**Model:** TA-E9000ES**No.** 628**Subject:** No Sound**Date:** April 3, 2000**Symptom:**  
**(1510)**

[Power Board ]

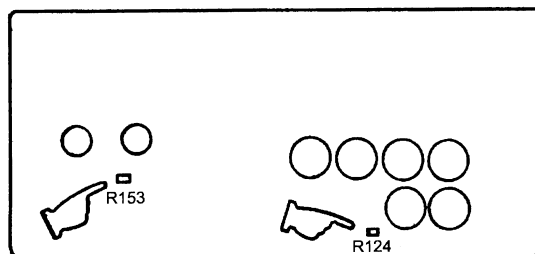
The customer complaints of no sound. Q108 on the powerboard may be overdissipated.

REF	FORMER		NEW	
	DESCRIPTION	PART NUMBER	DESCRIPTION	PART NUMBER
R124	4.7K 1/10W	1-208-453-41	4.7K 1 W	1-215-873-11
-	-	-	100 PF	1-163-117-11

**Procedure:**Replace any defective components. Add the 100pf capacitor in parallel to R153.  
Replace R124 with the 4.7K ohm 1W resistor.
